**New Britain
General**

March 20, 2002

In response to your letter of March 6, 2002 (Mail Control No. 130960), we can provide additional information as follows:

IRRADIATOR RM
NORTH BLDG - BASEMENT

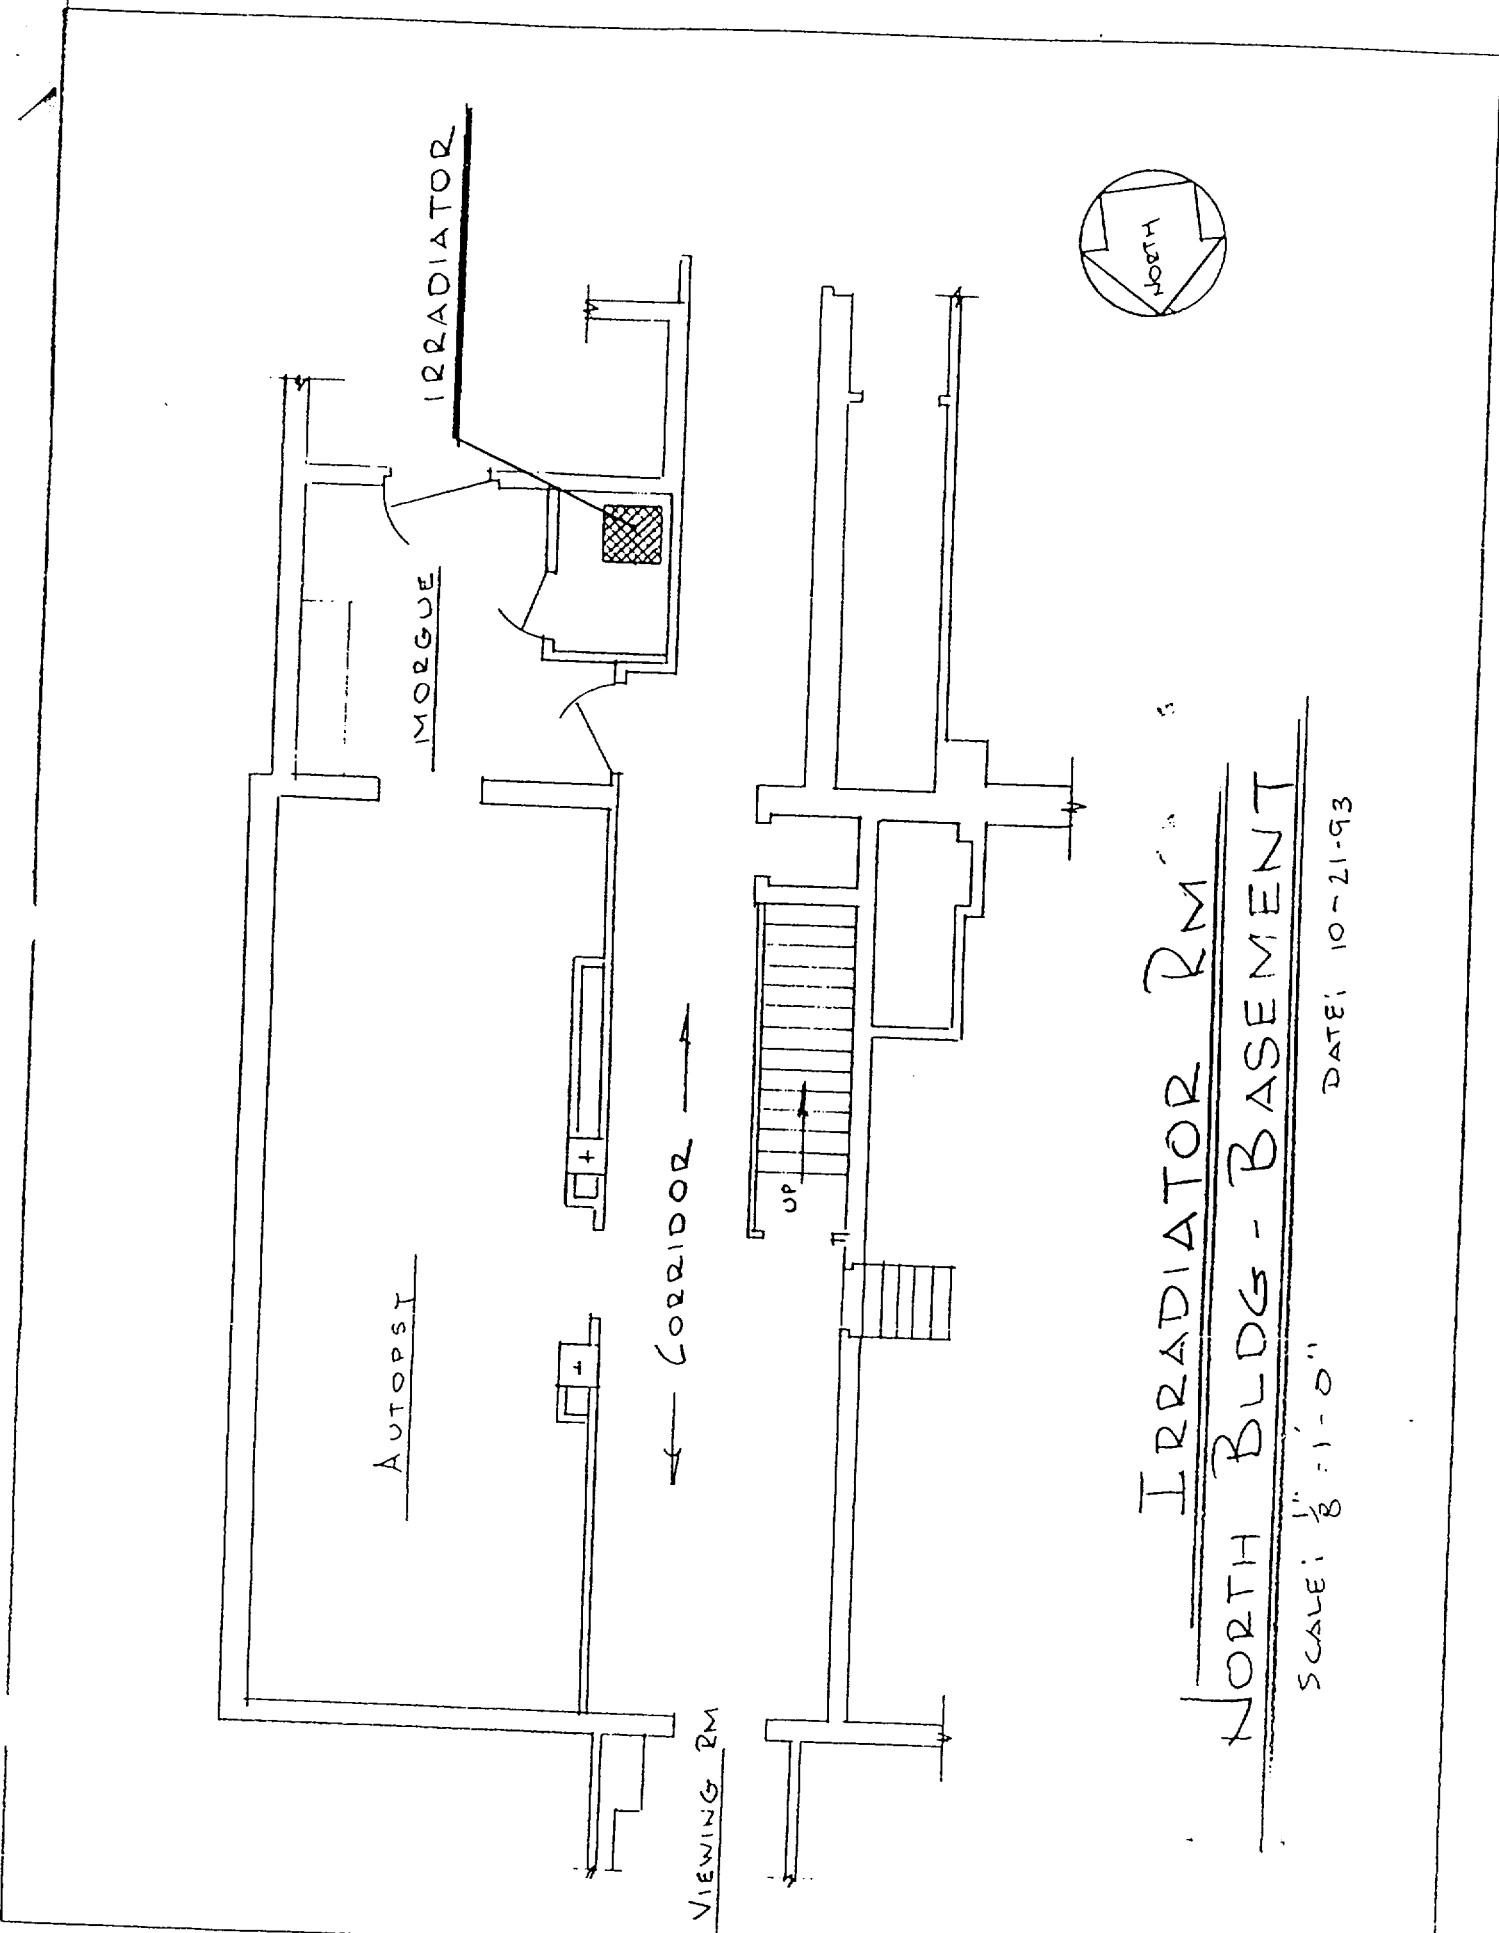
1. Diagrams of areas of use are attached. We regret if these were inadvertently not included in our application.
2. Please allow us to possess up to 15 GBq of materials listed in Part 35.300.
3. Procedures for use of blood irradiator have been revised since September 30, 1993. A summary of the revisions is attached.
4. We will establish and implement the model procedure for keeping an inventory of implant sources that was published in Appendix M.4 to Regulatory Guide 10.8, Revision 2.
5. Regarding the use of xenon-133 gas for lung imaging, we will collect spent xenon-133 in a shielded container and will establish and implement the model procedure for checking trap effluent that was published in Appendix O.3 to Regulatory Guide 10.8, Revision 2. We will calculate spilled gas clearance times according to the procedure that was published in Appendix O.4 to Regulatory Guide 10.8, Revision 2.

Per drawing submitted, in the basement of the hospital. Keys are held by blood bank supervisor and security. The irradiator room is equipped with fire detection and suppression (water sprinkler).
